**UTAH DIVISION OF RADIATION CONTROL  
ENERGYSOLUTIONS CLIVE LLRW DISPOSAL FACILITY  
LICENSE NO: UT2300249; RML #UT 2300249**

**CONDITION 35 COMPLIANCE REPORT; APPENDIX A:  
FINAL REPORT FOR THE CLIVE DU PA MODEL**

**SAFETY EVALUATION REPORT  
VOLUME 2**

**April 2015**

Figure B-1 – GoldSim versus HYDRUS infiltration flux

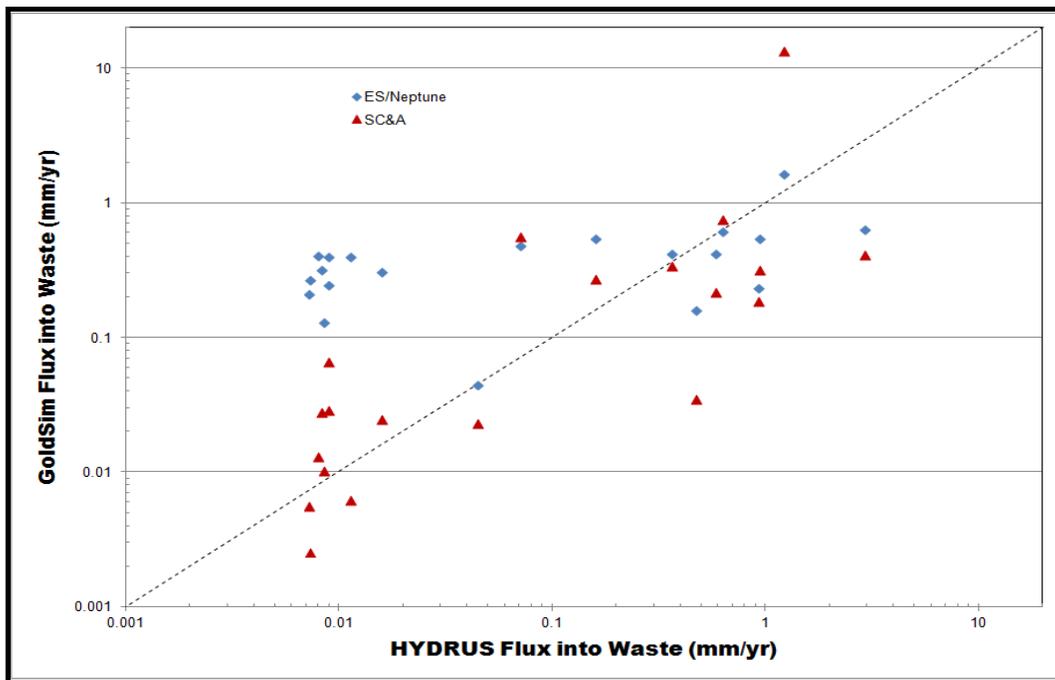
As an alternative to the linear regression, DEQ/SC&A fit an exponential equation to the van Genuchten  $\alpha$ ,  $n$ , and  $K_{sat}$  input data and the HYDRUS-calculated fluxes (Figure B-1). The triangles shown in Figure B-1 are the fluxes calculated using the following exponential fit:  $\text{Flux} = 45.465 \times \alpha^{1.4408} \times n^{-1.332} \times K_{sat}^{-0.445}$ . For large fluxes, the exponential fit does not appear to be much better than the linear fit, but for small fluxes (which tend to result when the van Genuchten  $\alpha$  is small), the exponential fit is much better than the linear fit.

Figure B-2 – Complementary cumulative distribution of HYDRUS and GoldSim  $\alpha$  parameters

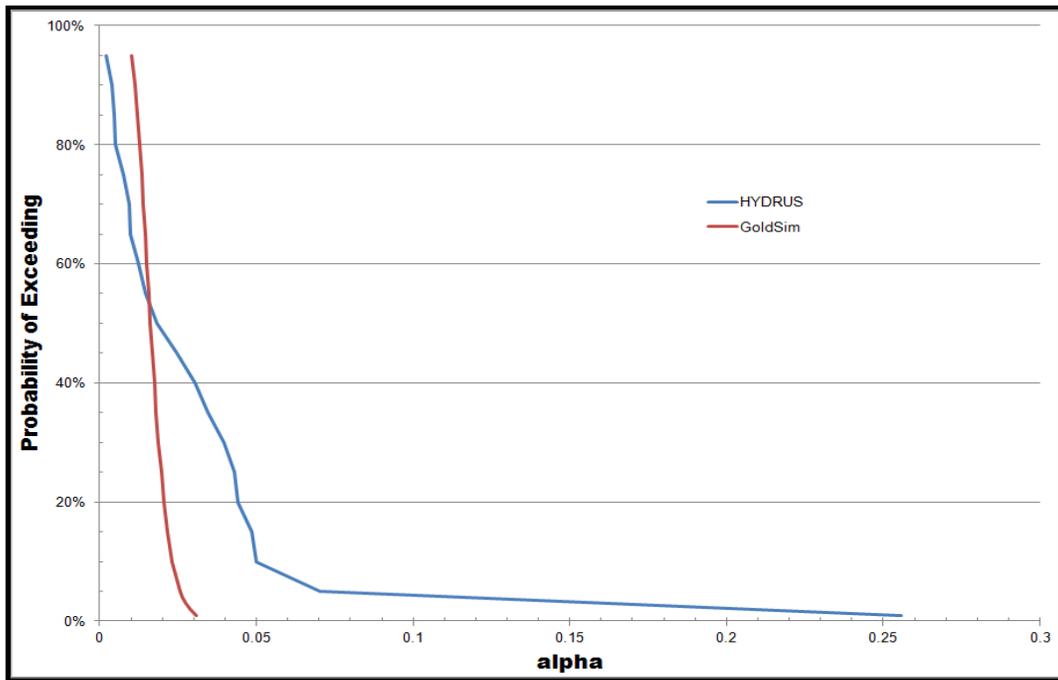
- 2) As acknowledged by *EnergySolutions* in its responses to Supplemental Interrogatories 1 and 2, due to scaling effects the ranges for  $\alpha$  and  $n$  that have been programmed into GoldSim are more narrow than those in HYDRUS (i.e., in HYDRUS,  $\alpha$  ranges from 0.001883 to 0.3021, but in GoldSim,  $\alpha$  only ranges from 0.005 to 0.0493; likewise, in HYDRUS,  $n$  ranges from 1.029 to 1.883, but in GoldSim  $n$  only ranges from 1.060 to 1.540). See Figure B-2 and Figure B-3 for complementary cumulative distribution (CCD) comparisons that were prepared by SC&A utilizing *EnergySolutions* HYDRUS results and the Neptune (2014b), Table 1 GoldSim  $\alpha$  and  $n$  distributions.

**Figure B-4 – Complementary cumulative distribution of HYDRUS and GoldSim infiltration fluxes**

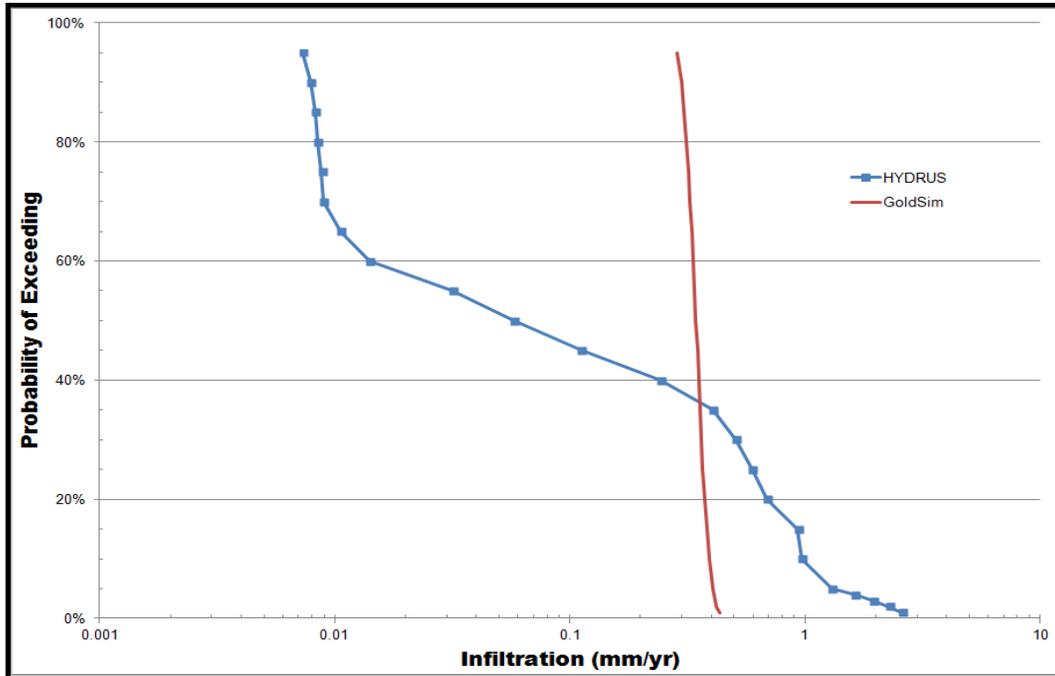
The CCD comparison in Figure B-4 shows the effect of these two mathematical considerations on the resulting GoldSim infiltration rate. This infiltration CCD is very similar to Figure 5 of the EnergySolutions Response to Supplemental Interrogatories, except that it is rotated 90 degrees.

Note that GoldSim was not re-run for these analyses. Instead, the GoldSim equations were programmed into an Excel Crystal Ball file, and 10,000 realizations were run. Also, the reason the GoldSim CCDs are smoother than the HYDRUS CCDs is that the GoldSim CCDs have 10,000 points, whereas the HYDRUS CCDs have only 20.
